Docket 50-305  
Operating License DPR-43  
Kewaunee Nuclear Power Plant  
Proposed Technical Specification Change Regarding Heatup and Cooldown Limit Curves and Request for Exemption to 10 CFR 50.60, 10 CFR 50.61, and Appendices G and H of Part 50

Response to the NRC's Request for Addition Information on  
Proposed Amendment 160

**RESPONSE TO NRC QUESTIONS REGARDING MARGINS TO BE  
USED IN MASTER CURVE INTEGRITY ASSESSMENT FOR  
THE KEWAUNEE NUCLEAR POWER PLANT**

Figure 1. Illustration of Margin in  $RT_{To}$  Definition

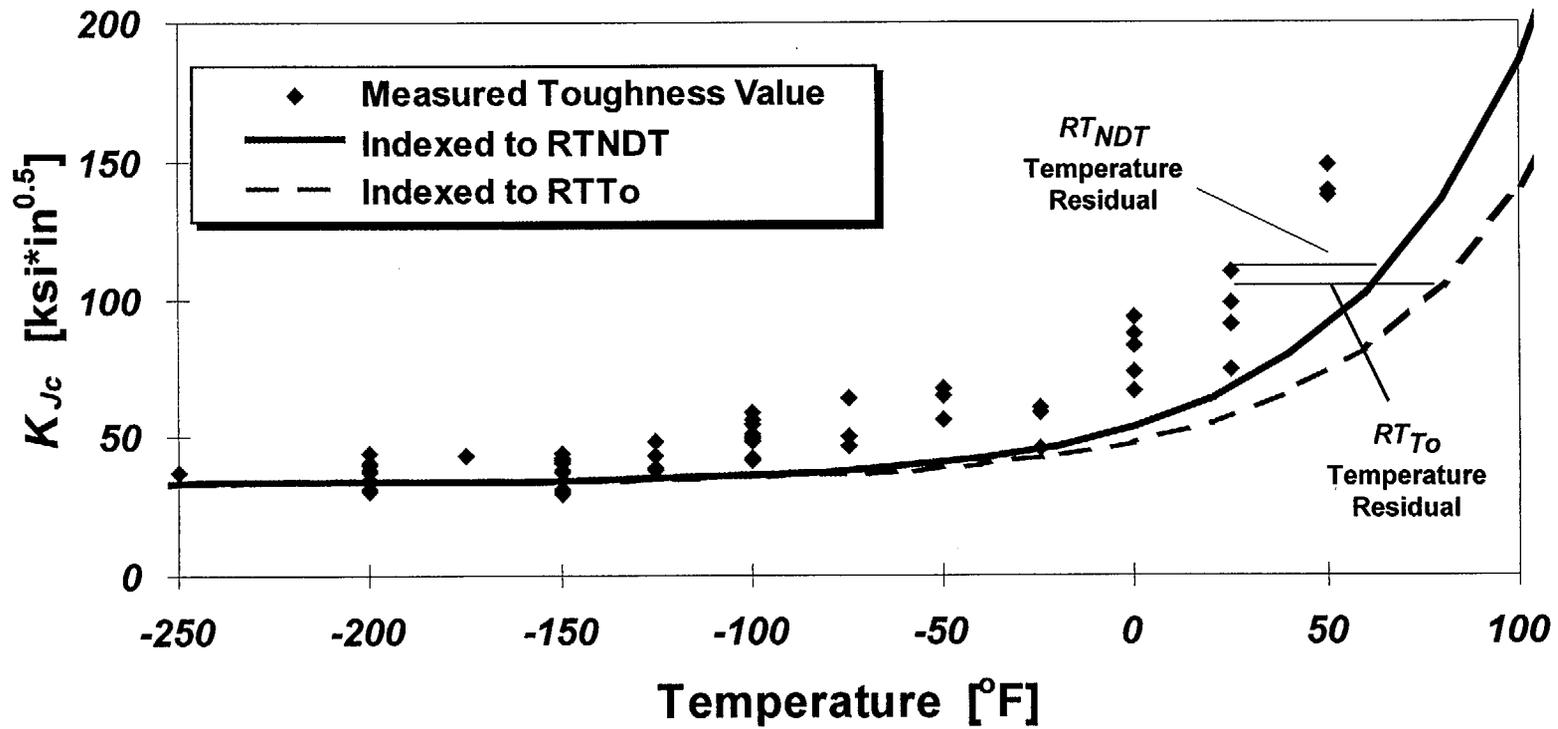
Since the Master Curve technology directly measures the properties of an irradiated material, it does not require measurements of unirradiated material properties to determine fracture toughness. The only place initial properties are used is in the ratio procedure; note that any variation in initial properties has little effect on the ratio procedure as used in the WPSC evaluation. Therefore, uncertainties associated with the measurement of initial properties do not affect the calculation of  $RT_{T_0}$ . The potential material variability in the irradiated  $RT_{T_0}$  determination has been considered.  $RT_{T_0}$  is defined as  $T_0 + 35^\circ\text{F}$  and is an empirical bound.  $RT_{T_0}$  is similar to  $RT_{NDT}$  in that it is also a bounding value. As such, material uncertainty is inherent in its definition. In fact, there is an inherent margin of  $18^\circ\text{F}$  on the most-limiting lower bound material, HSST Plate 02, when using the  $RT_{T_0}$  approach. As the most limiting material in the original database, HSST Plate 02 establishes the standard for the minimum acceptable spacing between the fracture toughness values and the reference fracture toughness curve (see Figure 1 for illustration). The use of  $RT_{T_0}$  provides a more consistent relationship between the data and the curve and increases the minimum acceptable spacing. The implied relationship between the fracture toughness data and the reference toughness curve is illustrated in Figure 1.

A measured  $RT_{T_0}$  is equivalent in application to a measured value of  $RT_{NDT}$ .  $RT_{NDT}$  is a bounding value and no additional margin is needed to cover uncertainty when the quantity is measured.  $RT_{T_0}$  also is a defined bounding value. But, in the June 7, 1999 submittal,  $RT_{T_0}$  was conservatively treated as a mean value, and the uncertainty in the measurement, due primarily to the known statistical distribution of the fracture toughness data, was added. Given the more appropriate use of the direct measurement methodology, it is expected that measurement uncertainties for  $T_0$ , and hence  $RT_{T_0}$ , are smaller than real measurement uncertainties for  $RT_{NDT}$ .

Figure 2. Variation in  $RT_{T_0}$  with Fluence for Kewaunee and Maine Yankee Materials

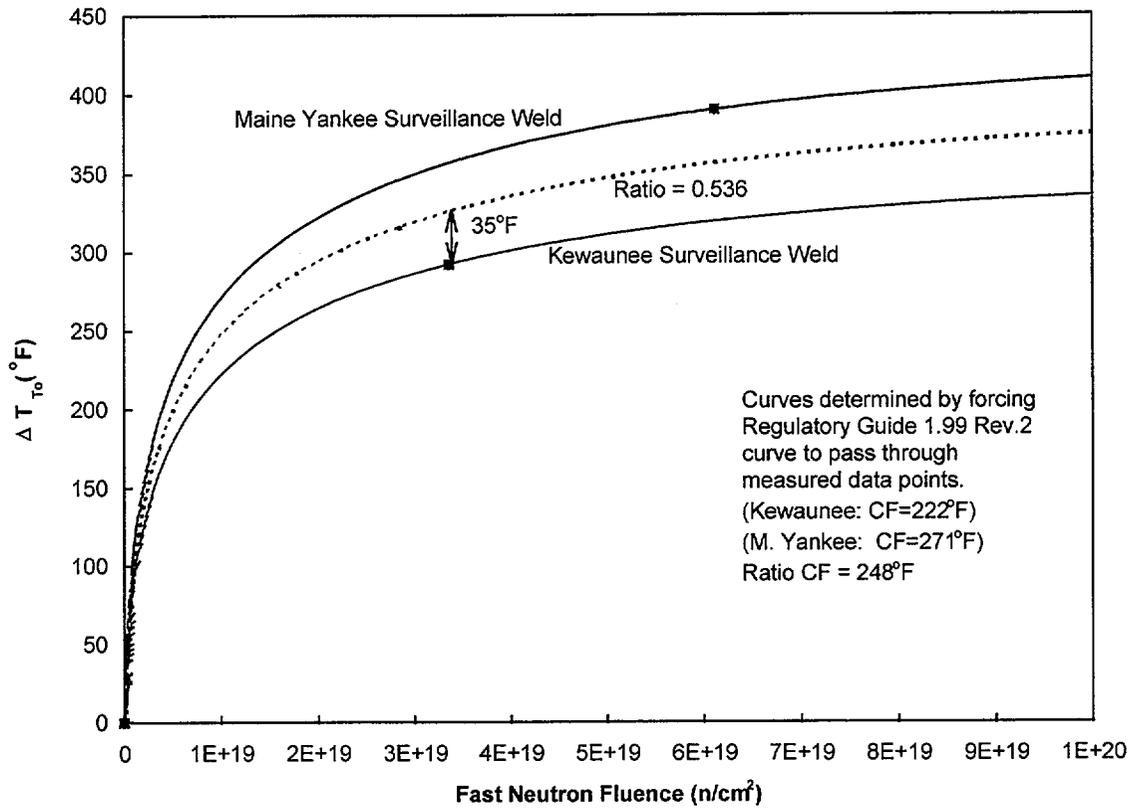
The value of R from the Charpy-based approach is an adjustment upward of  $39^\circ\text{F}$  above the Kewaunee surveillance weld projections (or equivalently,  $32^\circ\text{F}$  below the Maine Yankee surveillance weld projections). Using the measured  $RT_{T_0}$  values for the two surveillance welds, instead of Charpy data, results in a ratio adjustment of  $37^\circ\text{F}$  above the Kewaunee surveillance weld projections (or equivalently  $32^\circ\text{F}$  below the Maine Yankee surveillance weld projections). The higher level of variation in copper for weld wire heat 1P3571 is partially taken into account by the ratio normalization method. In particular, the Maine Yankee surveillance weld exhibits the highest overall mean for copper; the Kewaunee surveillance weld shows the lowest mean level for copper for the 1P3571 heat. The best-estimate copper content for the Kewaunee vessel (using the coil-weighted average of all of the industry data on weld wire heat 1P3571) is essentially midway between the Kewaunee and Maine Yankee surveillance weld mean values. The calculated ratio corresponds to 0.54 between the Kewaunee and Maine Yankee surveillance weld data as shown in Figure 2.

Figure 3. Master Curve Comparison with  $RT_{NDT}$  Approach Used to Develop PTS Screening Limits

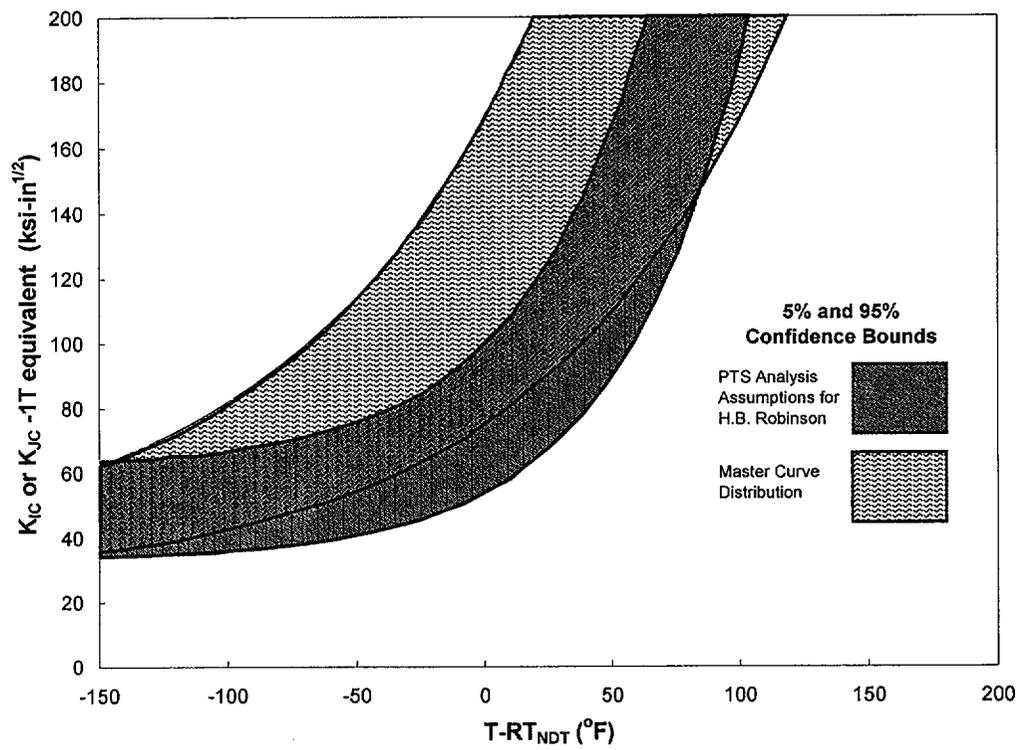
results in the relationship between the two distributions illustrated in Figure 3. The range of toughness values indicated by Master Curve confidence bounds is significantly broader than the corresponding range indicated by the confidence bounds used for the PTS Rule. Recent advances in the understanding of the statistical nature of cleavage fracture initiation indicate that the broader Master Curve distribution is more realistic. This distribution is inherent in the definition of  $T_0$  as outlined in ASTM E 1921-97. Therefore, for any measured value of  $T_0$ , the fracture toughness data must lie in the Master Curve range described in Figure 3. The distribution used for the original PTS Rule determination is narrower and concentrates the toughness values nearer the lower bound. The fracture toughness values used to evaluate conditional probabilities of failure in the PTS screening criteria analysis were drawn from this narrower distribution. Fracture toughness values sampled from the PTS distribution are generally low as compared to the more realistic Master Curve distribution. Use of these low values results in an overestimate of the conditional probability of failure. The use of  $RT_{T_0}$  in place of  $RT_{PTS}$  implies a level of conservatism that exceeds the level implicit in the current PTS screening criteria. This additional conservatism in the analysis is a manifestation of the inherent margin in the  $RT_{T_0}$  definition.

Figure 5. Coil-Adjusted Distribution of Cu Concentrations for Weld 1P3571

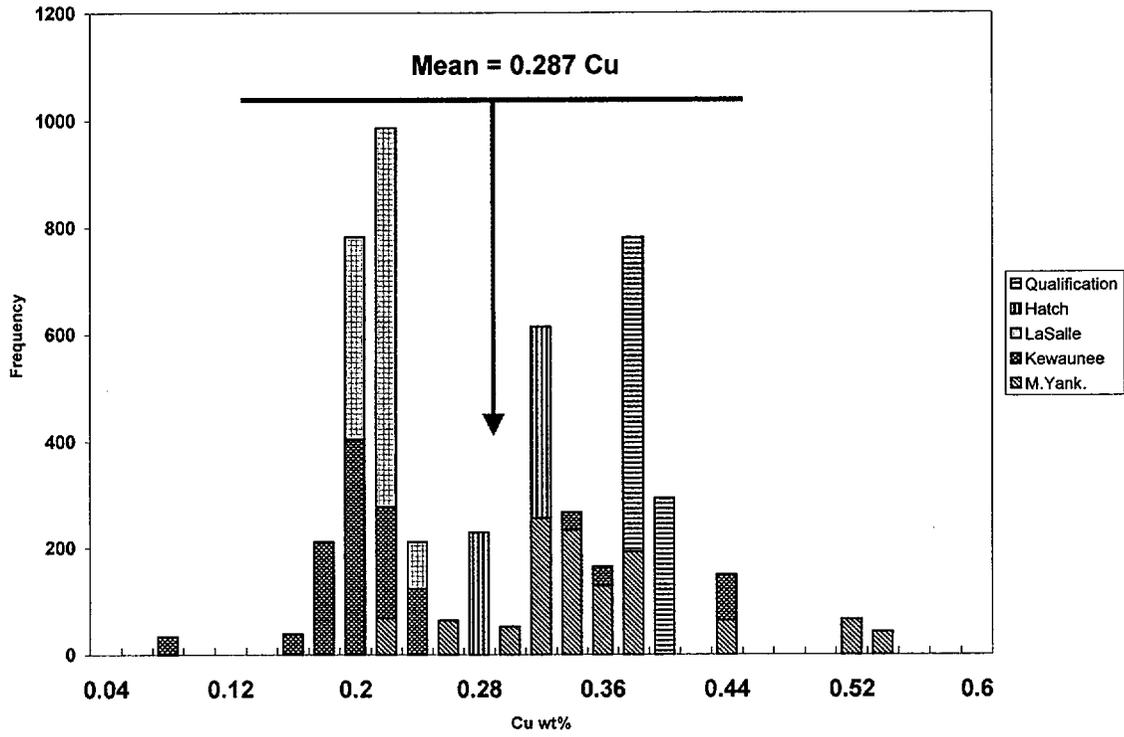
**Technical Approach:** The set of chemistry data for welds fabricated from wire heat 1P3571 contains information from six different weldments. These weldments include the Kewaunee, Maine Yankee, LaSalle-1 and Hatch-1 surveillance welds as well as two qualification welds (see Figure 5). These welds were all included in the determination of the coil-weighted average composition, using a weighting scheme that is related to the composition of the weld (see WCAP-15074). As previously indicated, the Kewaunee and Maine Yankee surveillance welds of heat 1P3571 have been analyzed extensively. These two materials exhibit distinctly different Cu distributions. Although the other 1P3571 data sets are smaller it appears that the remaining materials also exhibit characteristic distributions. The ratio method normalizes the measured Charpy shift to the mean behavior of the combined distribution. The mean Cu concentration for this distribution is 0.287 wt% and the standard deviation is 0.08 wt%. The distinct nature of the underlying distributions is clearly evident in the distribution. The width of the  $\pm 2\sigma$  band ( $\pm 0.16$  wt%) in the distribution is also indicated in Figure 5.

current regulatory margin generated in response to Question 1). 5000 random samples were selected from the illustrated Cu distribution. For this broadened distribution, the Cu portion of the standard deviation of the predicted Charpy shift is increased to 36°F. As indicated in the answer to Question 1, the 0.03 wt% standard deviation on Cu content assumed in the current regulations corresponds to a standard deviation of 13°F in Charpy shift. The factor of 2.8 increase in standard deviation is to be expected given the wide range of Cu levels included in this analysis. The impact on the overall margin term would not be as great since the other key uncertainties are combined using SRSS.

Figure 6. Effective Cu Distribution for Weld Heat 1P3571 Assuming 0.3 wt% Saturation

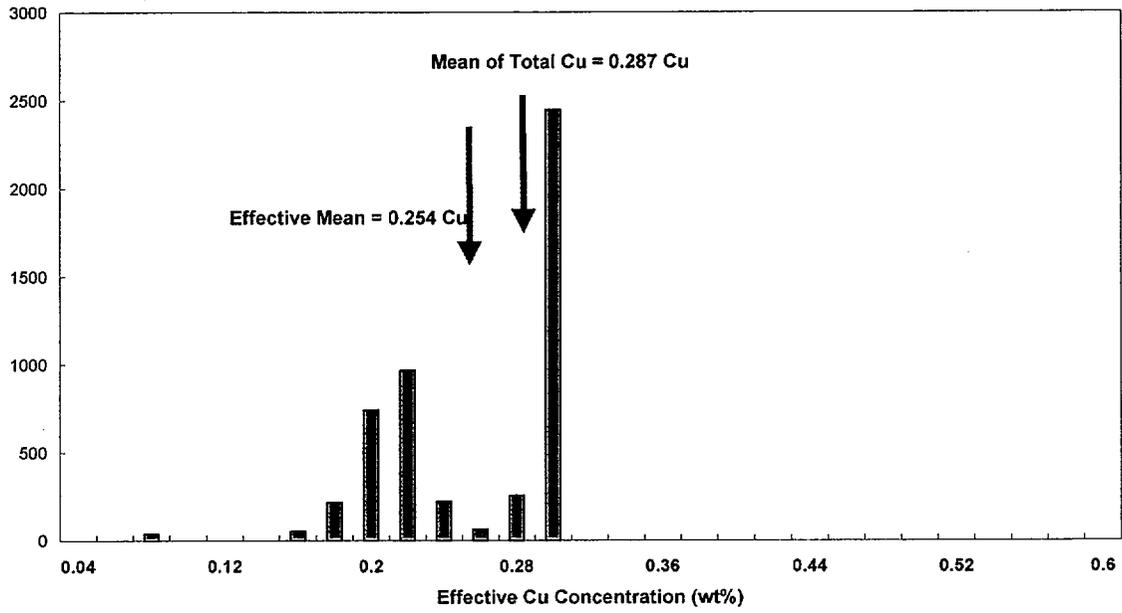
**Technical Approach:** The revised distribution of effective Cu concentrations due to copper saturation is illustrated in Figure 6. In this case, all 1P3571 weld metals with a Cu concentration greater than 0.3 wt% (as shown in Figure 4) are assumed to have an effective Cu concentration of 0.3 wt%. Compressing the high end of the distribution results in a lower mean value and a smaller standard deviation. These effects are obvious in Figure 6.
